**NOTICE OF ERROR
REPLY**

Water right number: 75-4154

IDAHO DEPARTMENT OF WATER RESOURCES
PRELIMINARY RECOMMENDATION OF WATER RIGHTS ACQUIRED UNDER STATE LAW

RIGHT NUMBER: 75-4154

75-4154

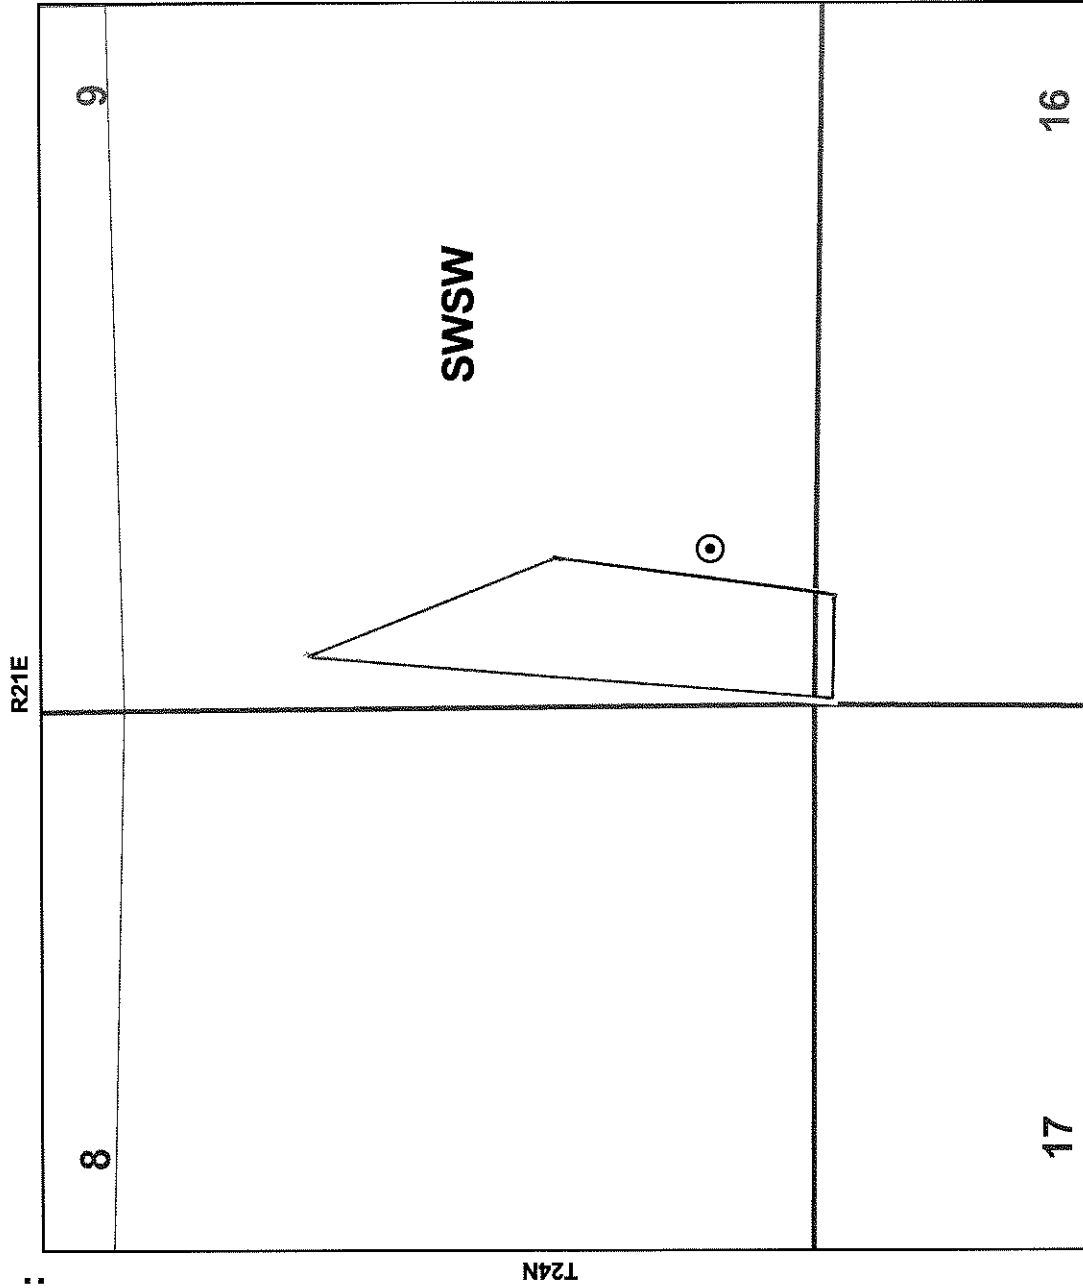
AS PER RESULTS FROM AREAS SUGGESTED IN IRRIGATION FLOW RATE
QUESTIONNAIRE IDFA WOULD LIKE TO INCREASE DIVERSION QUANTITY FROM 0.12 CFS
TO 0.5 CFS.

THE SURFACE DITCH ACROSS THE HEADLAND IS 730' LONG WITH A 3 FOOT WIDTH & 2 FOOT DEPTH. THE
SOILS ARE GRAVELLY AND VERY POROUS RESULTING IN SIGNIFICANT SEEPAGE. CONSULTATIONS WITH LOULU
NRCS OFFICE INDICATE 0.5 CFS SHOULD BE ADEQUATE. SEE ATTACHED QUESTIONNAIRE
